CONWAY HISTORIC DISTRICT COMMISSION MEETING

**OLD CONWAY DESIGN OVERLAY DISTRICT
CERTIFICATE OF APPROPRIATENESS REVIEW
NEW FLOOD RESIDENCE AT 2015 SCOTT STREET**

OLD CONWAY DESIGN OVERLAY DISTRICT CERTIFICATE OF APPROPRIATENESS REVIEW NEW MANLEY RESIDENCE AT 1810 MILL STREET

**OLD CONWAY DESIGN OVERLAY DISTRICT
CERTIFICATE OF APPROPRIATENESS REVIEW
BAKER RETAIL CENTER AT 1076 HARKRIDER STREET**

NORTH (FRONT) ELEVATION

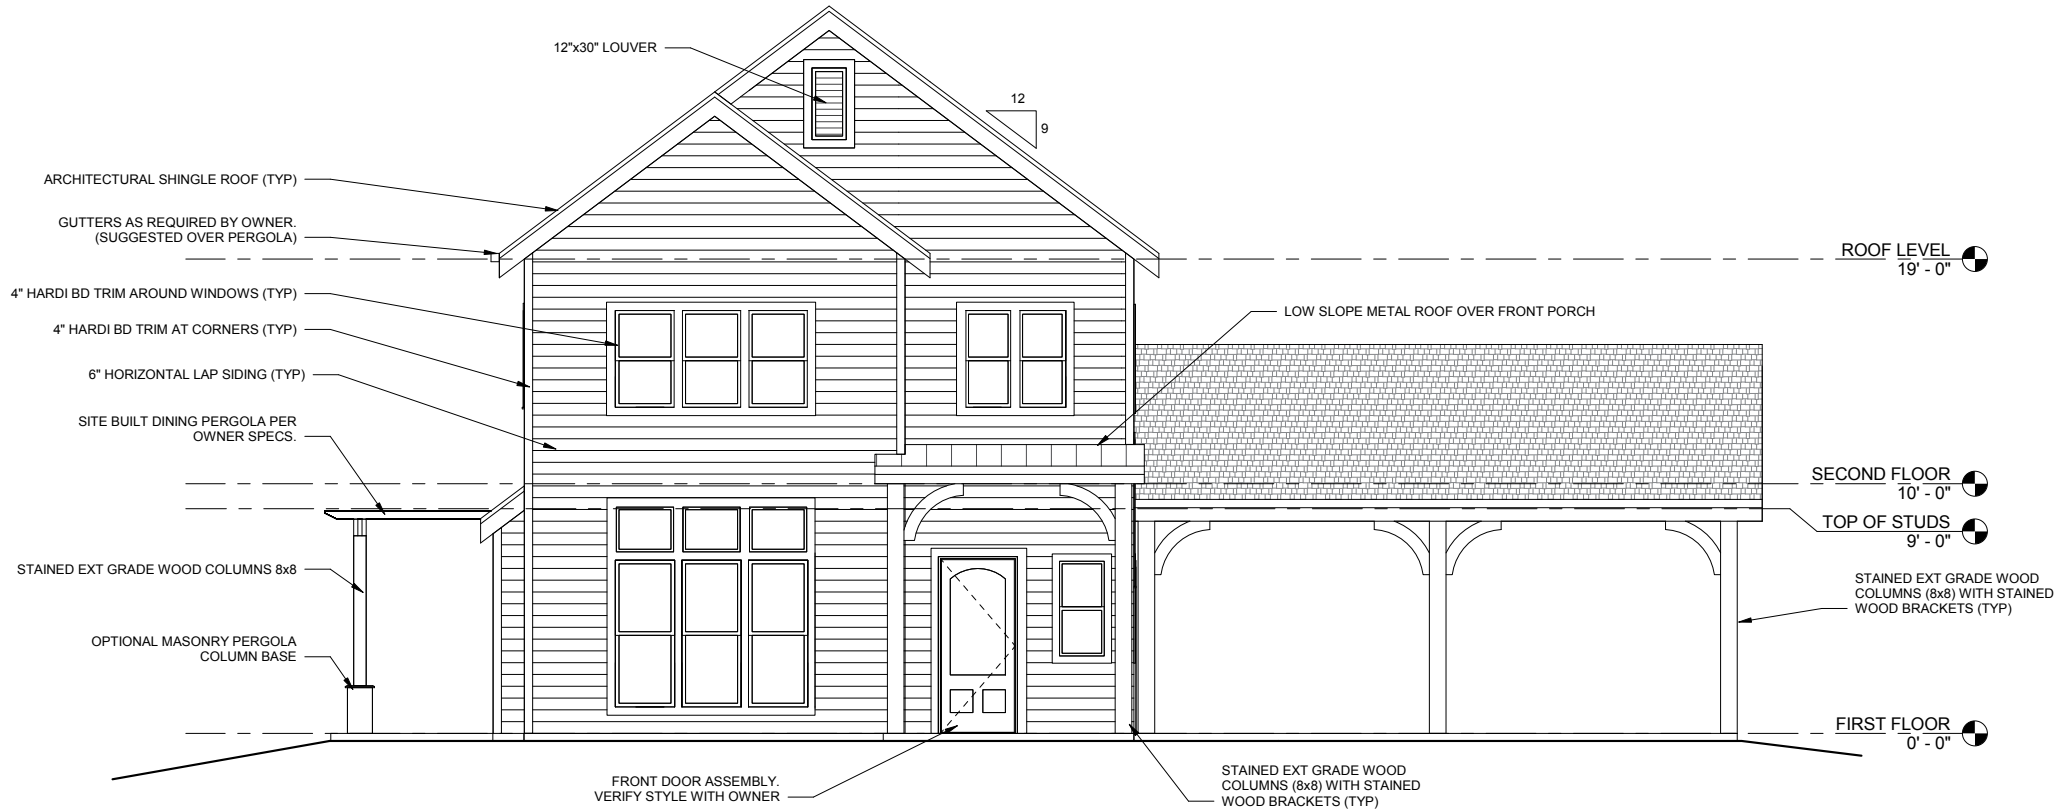
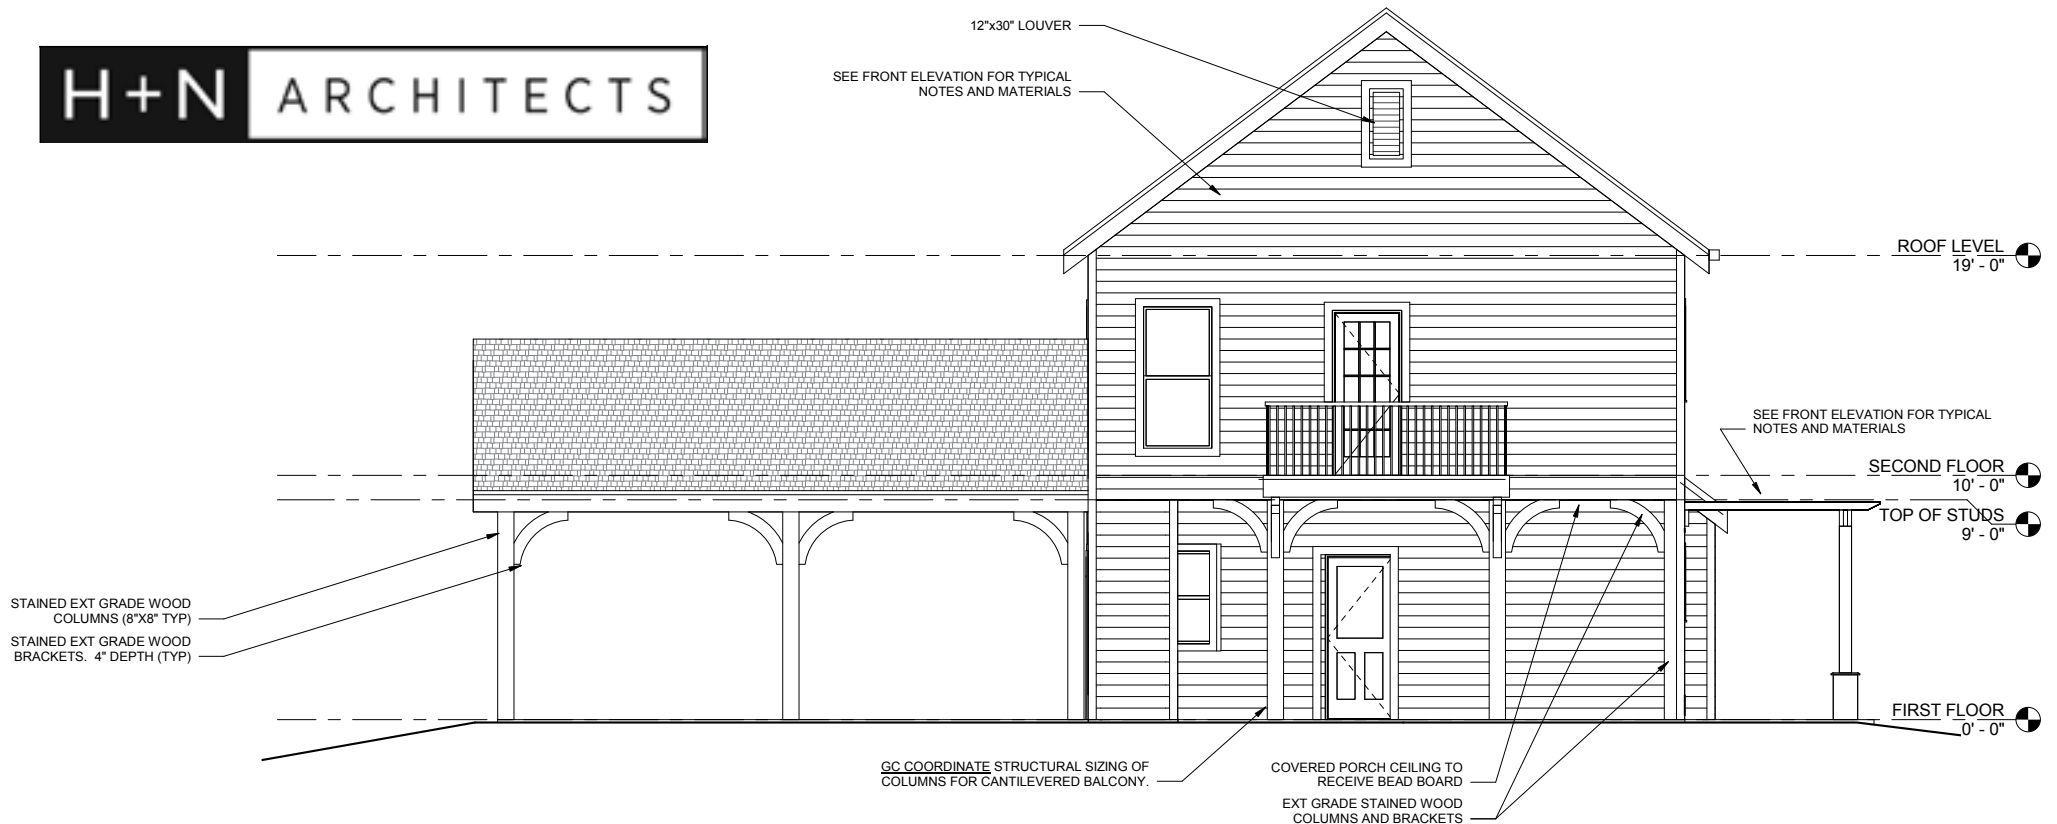
Sidewalks. There are no sidewalks along the Scott Street frontage. A 5 foot sidewalk is proposed. Other area sidewalks appear to be around 4 feet. The sidewalk could be reduced to 4 feet in width.

Entries, Porches, and Porticos. Appropriate entry points are provided. Porches are to be a minimum of 6 feet in depth. The front porch is shown at around 5 feet in depth and 9 feet wide. The depth could be increased to 6 feet to provide additional sitting area. There is a large rear covered porch, rear balcony, side pergola, and carport. All columns are shown appropriately trimmed at 8" x 8".

1. The residence and driveway shall be constructed as shown in submitted plans.
2. The residence's front setback shall be approximately 14 feet from the property line to the main facade wall.
3. Front porch shall be 6 feet in depth minimum.
4. Porch columns shall be a trimmed out to 8 inch by 8 inch minimum.
5. First floor to ceiling height shall be approximately 9 feet.
6. Fiber cement siding shall be used as shown.
7. Wide trim around windows and doors and mixture of roofing materials shall be used as shown.
8. HVAC and utility equipment shall be appropriately located at the rear or side of the structure and/or appropriately screened.
9. A 4 foot sidewalk shall be constructed along Scott Street.

SITE PLAN

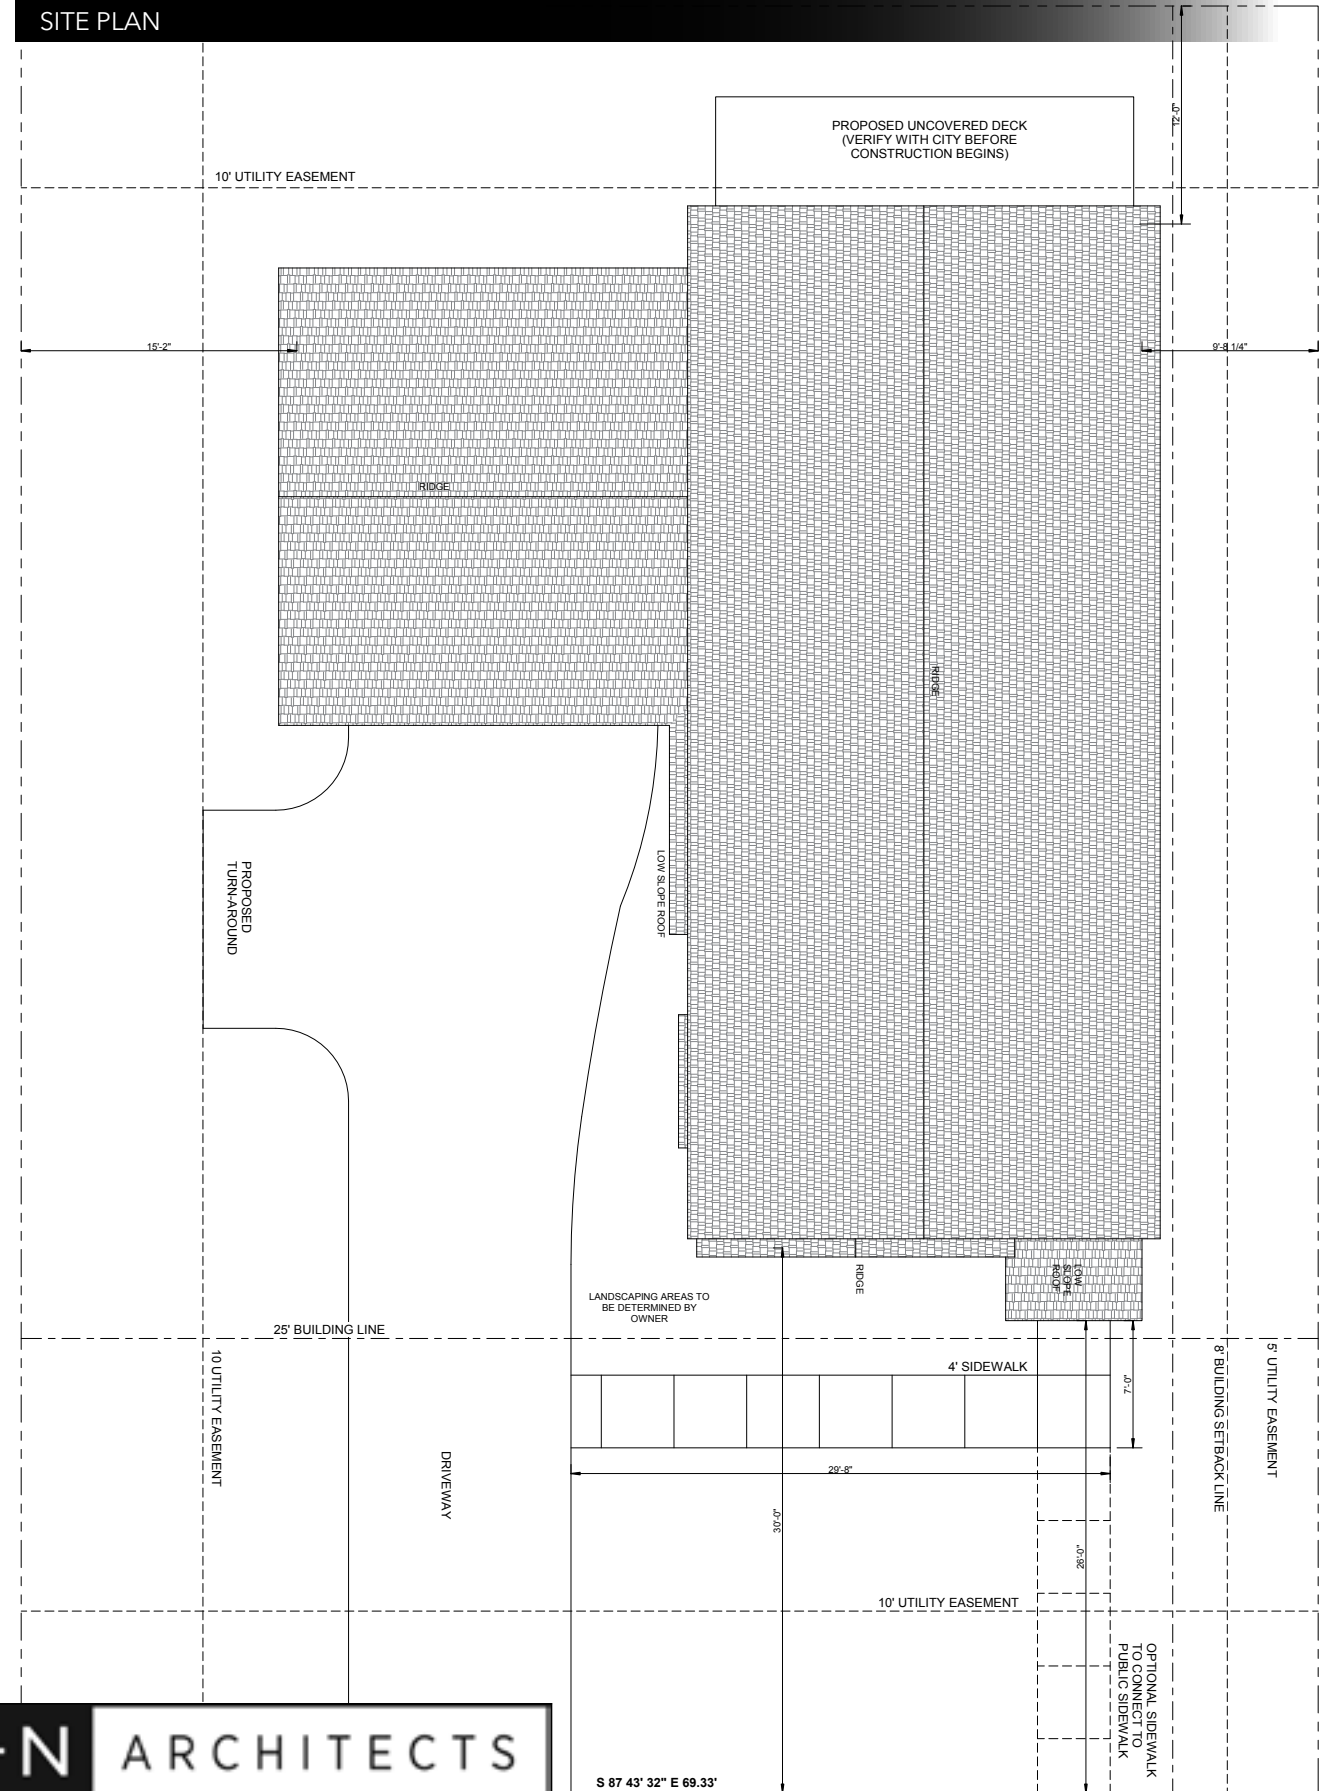
Fences. No fencing is proposed. There is an existing chain link fence surrounding the property. This fence should be removed in the front yard area.

Entries, Porches, and Porticos. Appropriate entry points are provided. Porches are to be a minimum of 6 feet in depth. The front porch is more of an entry portico rather than a "sitting" porch. It's shown at 5'-4" in depth and 7'-6" wide. Portico columns are appropriately wide at 8" x 8".

1. The residence and driveway shall be constructed as shown in submitted plans.
2. Chain link fence shall be removed from front yard.
3. The residence's front setback shall be approximately 26 feet from the property line to the proposed portico. (30 feet from property line to front facade wall.)
4. Porch columns shall be trimmed out to 8 inch by 8 inch minimum.
5. Floor to ceiling height shall be 9 foot minimum.
6. Siding material shall be cement fiber board as shown.
7. Wide trim around windows and doors as shown shall be used.
8. HVAC and utility equipment shall be appropriately located at the rear or side of the structure and/or appropriately screened.

SIDE & REAR ELEVATIONS

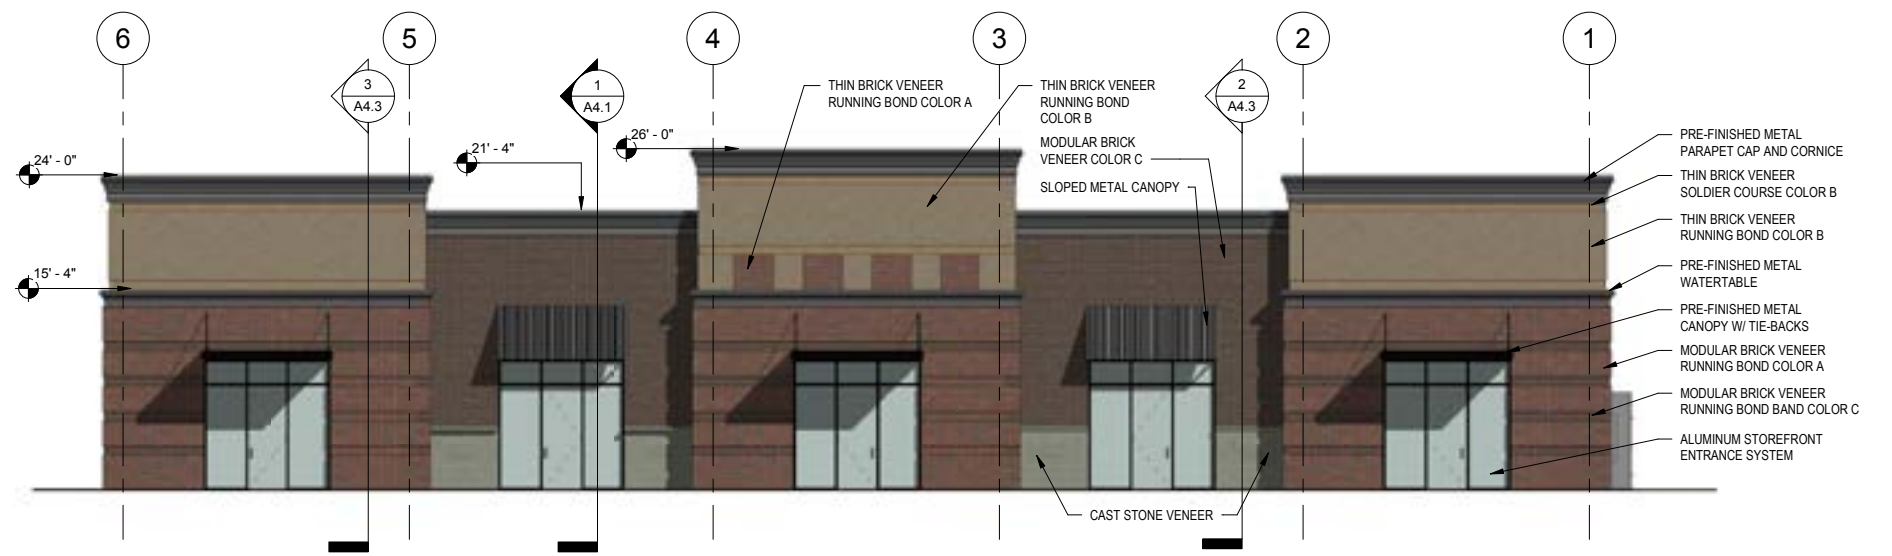
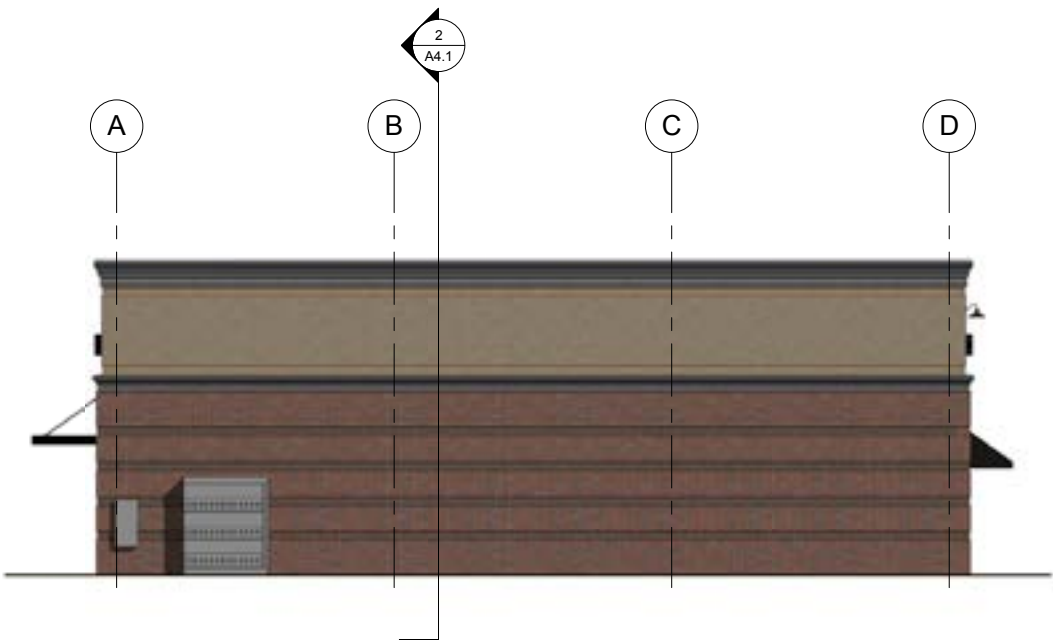
Complexity of form. The level of detailing and breaks in wall planes of a structure. There are several breaks in the front and rear wall planes. Pilasters, recessed glass, awnings, and masonry coursing create an appropriate complexity of form on the front and rear elevations. However, the north elevation is lacking details and is very visible at the corner Garland and Harkrider. Additional glass or some corner feature should be considered. The south facing facade will be mainly hidden from public view against the existing Baker medical building.

Mechanical Screening. HVAC units should be visually located away from streets or screened by landscaping. Exterior HVAC ductwork should not be visible from the street. HVAC equipment is shown as roof top mounted. The HVAC equipment appears as visible in the elevation, but will likely not be as prominent in actual perspective Development review regulations require all viewable HVAC equipment to be screened.

1. The office/retail building and parking lot shall be constructed as shown in submitted plans. Modifications due to technical reasons may be approved by the Planning Director.
2. Setbacks as shown on submitted plans shall be allowed.
3. The structure may be one story with the appropriate 2 story height as shown on submitted plans.
4. The southwest corner of the building shall have additional glass storefront and/or additional detailing to be approved by the Planning Director.
5. Harkrider Street sidewalks shall be constructed as shown on submitted plans in conjunction with the City approved Oak/Harkrider Street detail. This sidewalk and construction details shall be coordinated with the City and utilities. Sidewalks shall be required along the Garland and Hamilton Streets.
6. HVAC equipment shall be screened as required by Planning Staff development review.
